G-WILLS LIQUORS STORE
 RAMSEY, MN

EXISTING CONDITIONS, TREE INVENTORY,
 AND REMOVALS PLAN
 RAMSEY, MINNESOTA

SHEET C6
 OF C12 SHEETS

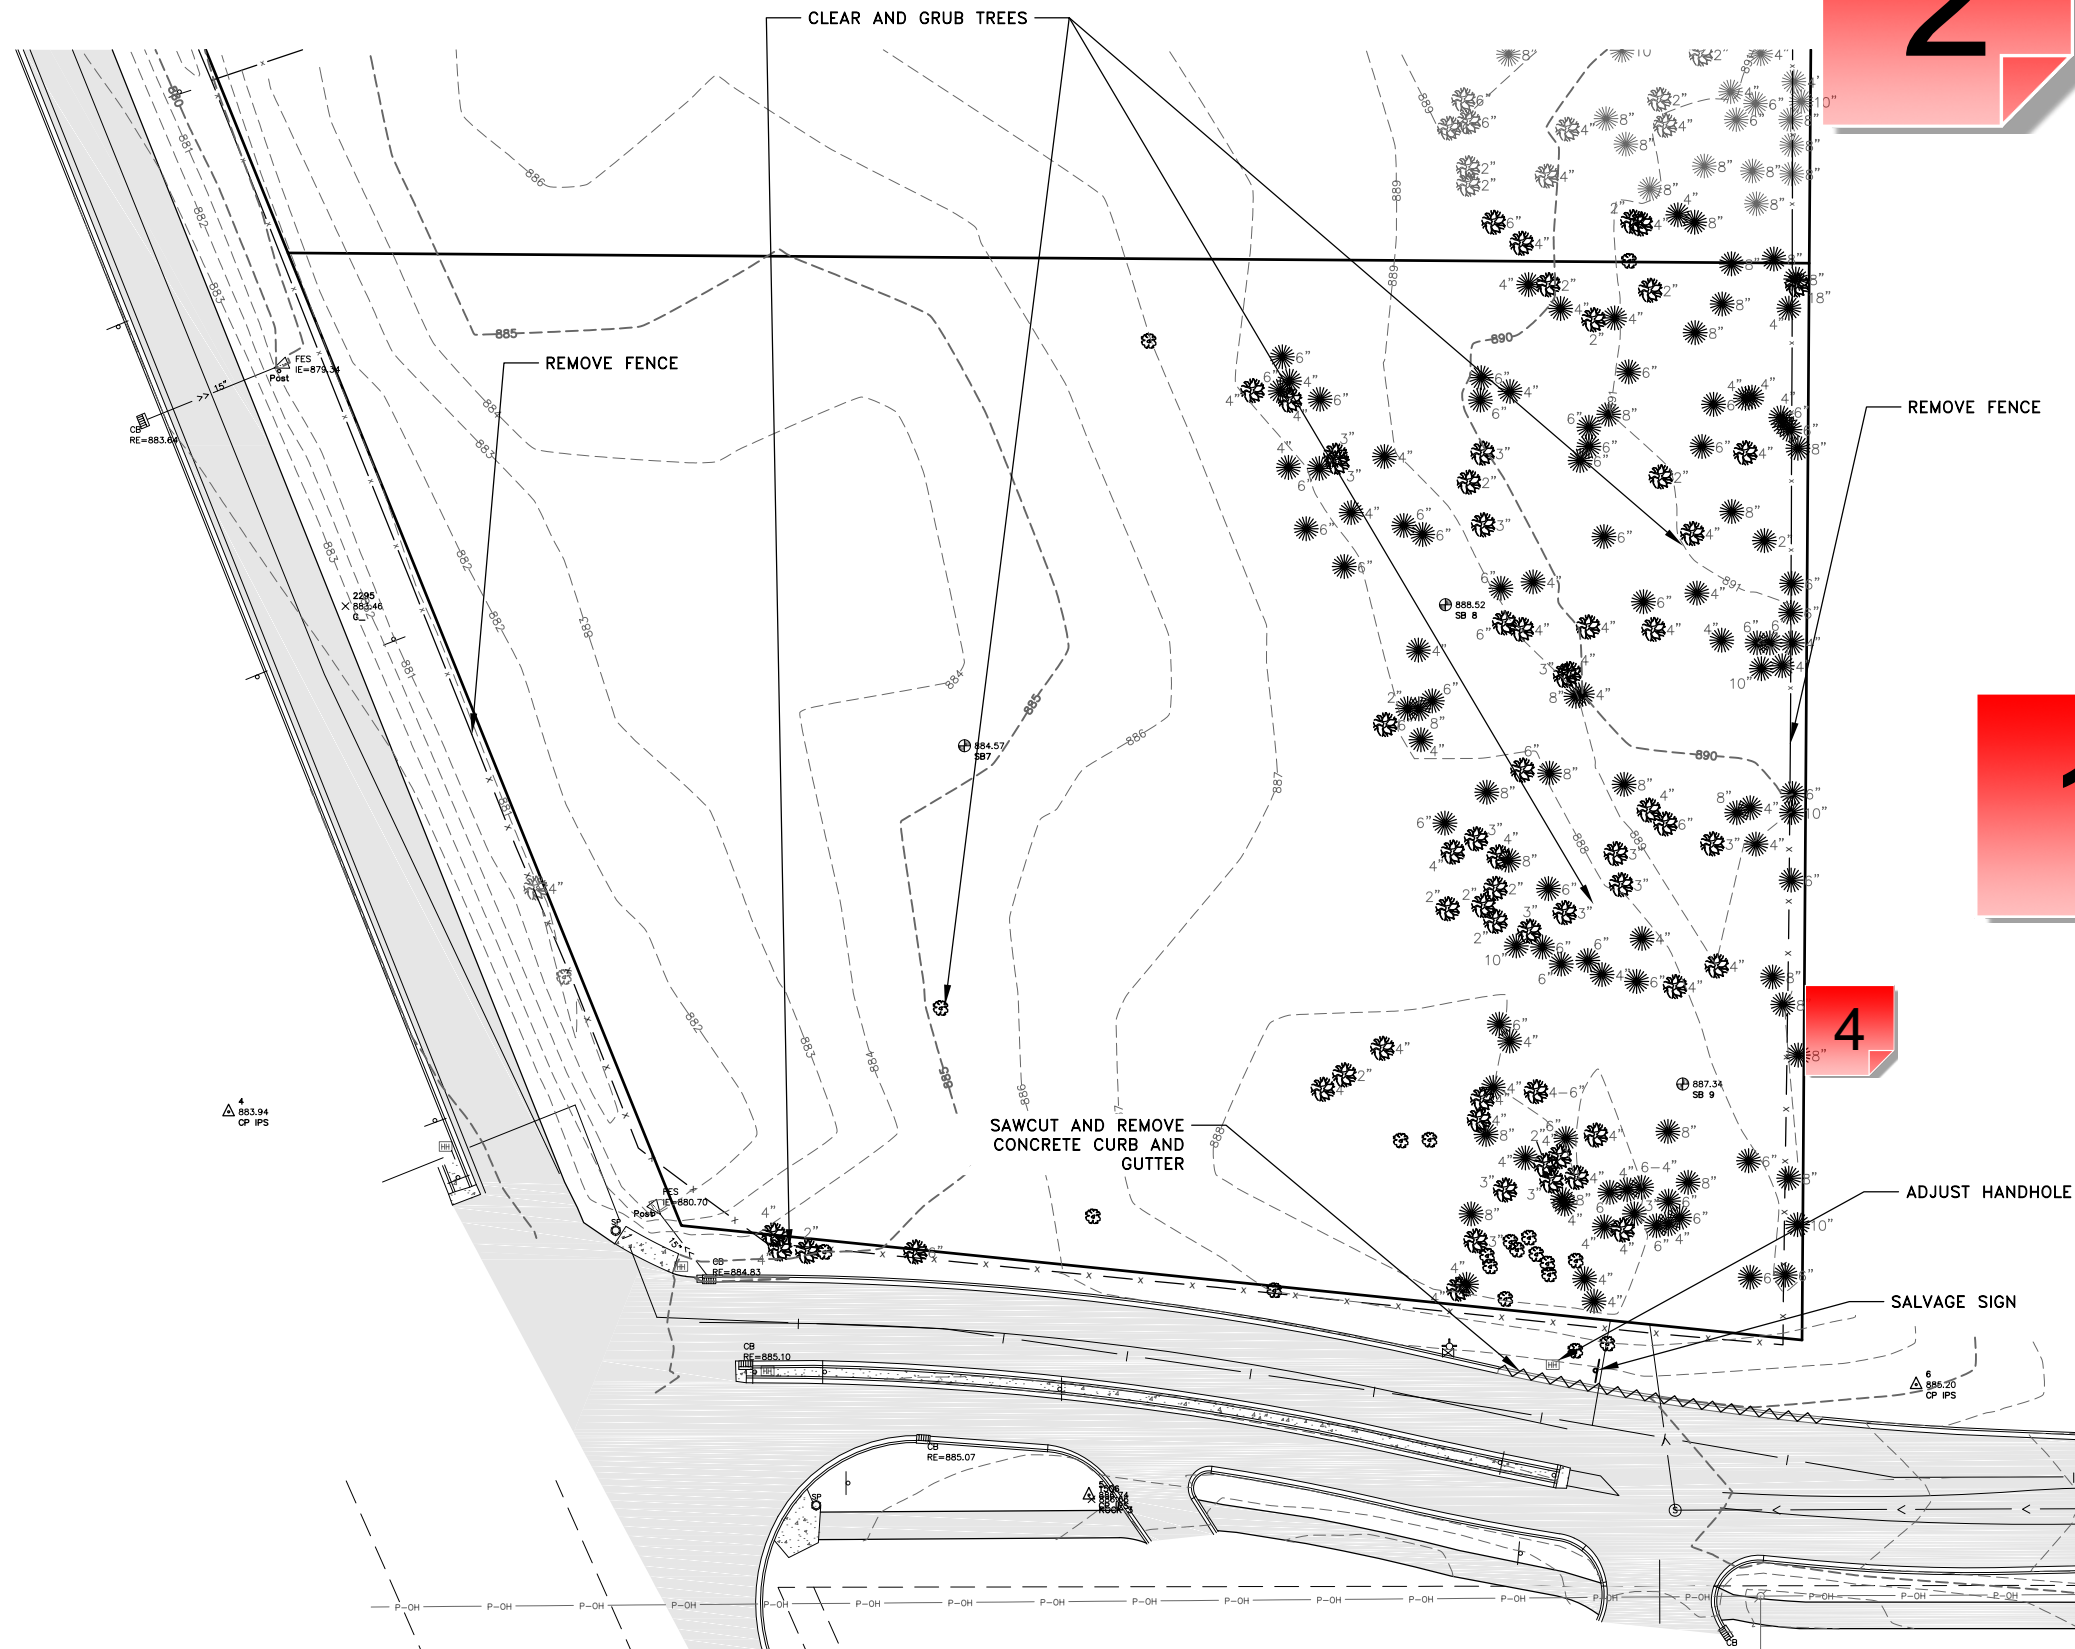
Need to include a table that identifies, at a minimum, species, DBH, status (preserve or remove), and if it is to be removed, a brief description of why (e.g. building pad, mass grading, stormwater pond, etc.).

Table should also include a total tabulation of all significant tree DBH inches, total DBH inches to be removed, and total DBH inches to be saved.

Note that any oak or evergreen tree with DBH of 4+ inches and all other trees with DBH of 8+ inches must be included on the Tree Inventory.

Any clearing activities involving oak trees shall not be conducted between April 15 and July 15 to avoid the typical high risk oak wilt season.

If more than 70% of the significant tree DBH inches are removed, reforestation is required. For every 1 inch over the removal threshold, 1.25 inches shall be installed. This shall be shown in a separate Planting Schedule table on the Landscape Plan.

Isn't there the ability to preserve some of the existing trees along the eastern boundary? They could count toward the bufferyard plantings and base landscape planting requirements.

Examine proposed grading to see if it could be adjusted somewhat to protect some of these existing trees.
